April 1, 2016

**American Council for an Energy-Efficient Economy | Environmental Defense Fund
Natural Resources Defense Council | Sierra Club | Union of Concerned Scientists**

**RE: Docket ID Nos. EPA-HQ- OAR-2014-0827 and NHTSA-2014-0132
Greenhouse Gas Emissions and Fuel Efficiency Standards for Medium- and Heavy-Duty Engines and
Vehicles - Phase 2 - Notice of Data Availability**

Source: Volvo comments on Phase 2 proposal, p.27

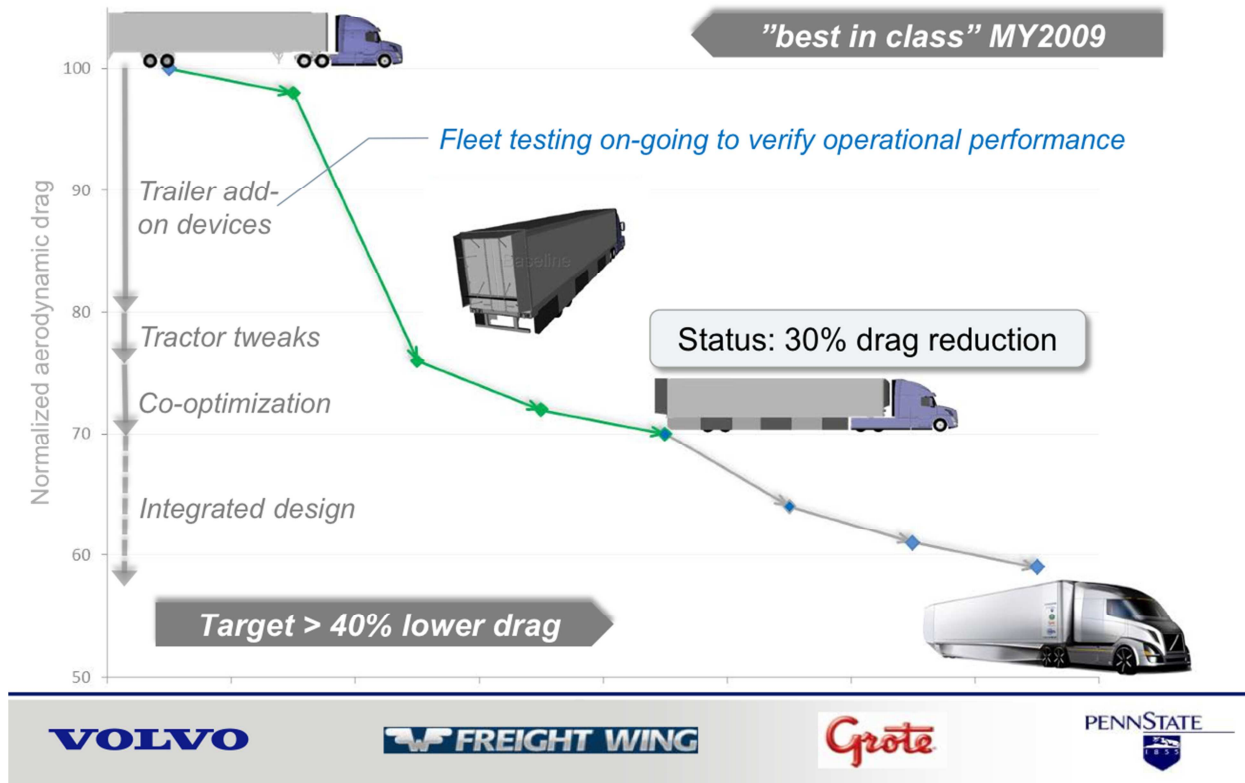
In addition to incentivizing co-optimization, this change to the standard trailer would make it feasible to achieve drag levels better than those in the compliance package. Volvo asserts (comments p.27; table replicated below) that its SuperTruck tractor would reach only bin IV (CdA = 5.43) with the proposed Phase 2 standard trailer, falling slightly short of the 2027 target (CdA = 5.32). However, the table shows that Volvo’s SuperTruck tractor paired with its Super Trailer would achieve CdA = 4.31. A Volvo SuperTruck presentation (http://energy.gov/sites/prod/files/2014/07/f17/vss081_amar_2014_o.pdf, slide 10) suggests that this result is achieved through trailer add-on devices followed by co-optimization. The graphic (replicated below) suggests that co-optimization alone reduces CdA by about 0.27, which is more than sufficient to meet the 2027 target, even after the target has been adjusted to reflect the trailer add-on devices.

Hence, we recommend that the agencies redefine the standard trailer as one having delta CdA matching the average for the appropriate model year. The tractor standard stringency should then be adjusted accordingly. In addition, the agencies should consider allowing testing with more advanced/integrated trailers.
